AN ORDINANCE APPROVING A PRELIMINARY DEVELOPMENT PLAN LOCATED AT 114 SE DOUGLAS ST IN DISTRICT CBD, PROPOSED DTLs APARTMENTS IN ACCORDANCE WITH THE PROVISIONS OF CHAPTER 33, THE UNIFIED DEVELOPMENT ORDINANCE OF LEE'S SUMMIT CODE OF ORDINANCES, FOR THE CITY OF LEE'S SUMMIT, MISSOURI.

February 8, 2019

RE: **Public Hearing - Appl. #PL2018-234 – PRELIMINARY DEVELOPMENT PLAN – DTLs Apartments, 114 SE Douglas St; Cityscapes Properties, LLC, applicant**

1 Typical Building Floor Plate

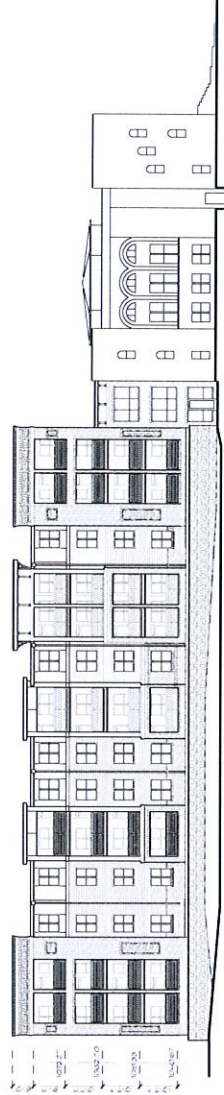
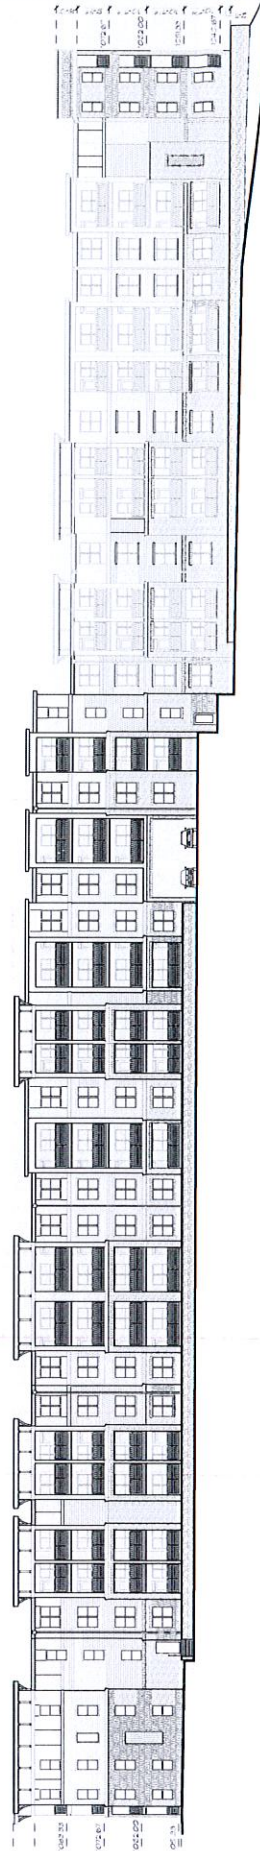
Building materials. Modification requested. **Staff supports the requested modification.**

- Required – First and second floor elevations of street facing facades shall consist of brick.
- Proposed – Modify the Design Standards for the Downtown Core Area's requirement that first and second floor elevations of street facing facades consist of brick, to allow for the brick facade to be one story in limited areas, consistent with the preliminary development plan date stamped January 22, 2019

- Recommendation – The applicant has stated in order to create a more dynamic façade, they varied masonry height. Rather than have a static two-story band of masonry, the brick facade has been raised up to the full four-story height in some locations, and dropped down to one story in limited, mostly recessed spaces. The varying of the height helps to reinforce base, middle and top across the various elements of the façade. Staff finds this justification to be reasonable and supports the requested modification.

3. A modification shall be granted to the Design Standards for the Downtown Core Area's requirement that first and second floor elevations of street facing facades consist of brick, to allow for the brick facade to be one story in limited areas, consistent with the preliminary development plan date stamped January 22, 2019.
4. The Developer shall execute a mutually satisfactory development agreement with the City, which addresses, at a minimum, sanitary sewer improvements and other required public improvements, and which carries out and implements the requirements and conditions of this ordinance. No building permit shall be issued for any structure in the development until written proof is provided to the City that the development agreement, or a memorandum thereof, has been recorded in the Jackson County Recorder's Office.
